REFERENCE:	Nova Bus Manuals
SECTION:	16: Electrical system
RS N°:	MQR 7621-620
EFFECTIVE IN PROD.:	—

SUBJECT:	Protective loom on the WHA electrical harness
JUSTIFICATION:	The protective loom on the WHA electrical harness may be damaged by the heat of the turbo.

Figure 1 - Location to Look at on the WHA 61 Electrical Harness (View from Engine Radiator Side)

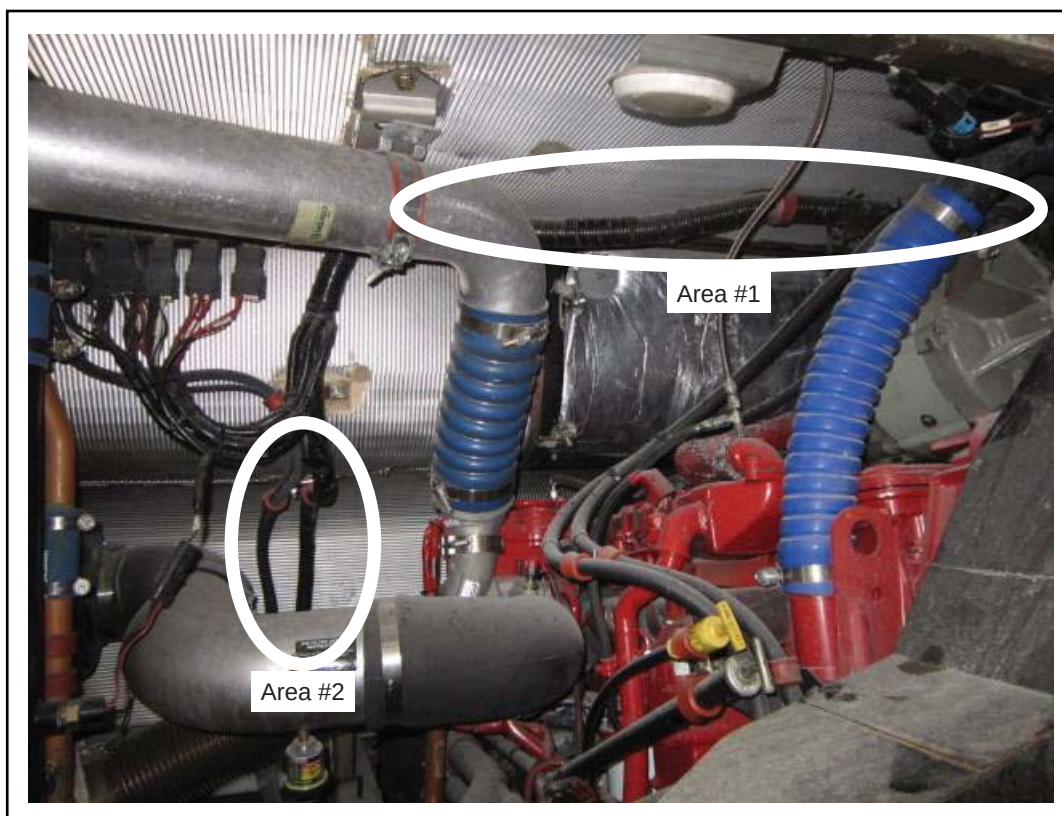
- 1.1. Open the rear engine access door.
- 1.2. Open the street side engine access door.
- 1.3. Open the transmission access door.
- 1.4. Open the engine access door under the rear passenger seat.
- 1.5. Remove the P-clamps on the WHA 61 electrical harness located in the two areas close to the engine turbo. See Figure 1. Retain the hardware.
- 1.6. Inspect the slit convoluted conduit in area #1. See Figure 1.

- 1.7. If damage is detected, go to the next step. If no damage is detected, go to step 1.10.
- 1.8. Remove the damaged convoluted conduit.
- 1.9. Install an appropriate length of new N28083-10 convoluted conduit to cover the entire damaged area. Tape the conduit in place with N74787 electrical tape. Install two turns of tape on every six inches (150 mm) along the convoluted conduit.

- 1.13. Inspect the slit convoluted conduit in area #2. See Figure 1.
1.14. Repeat steps 1.7 to 1.12 for area #2.
1.15. Close all four engine and transmission access doors.
1.16. The vehicle may be returned to service. ❖
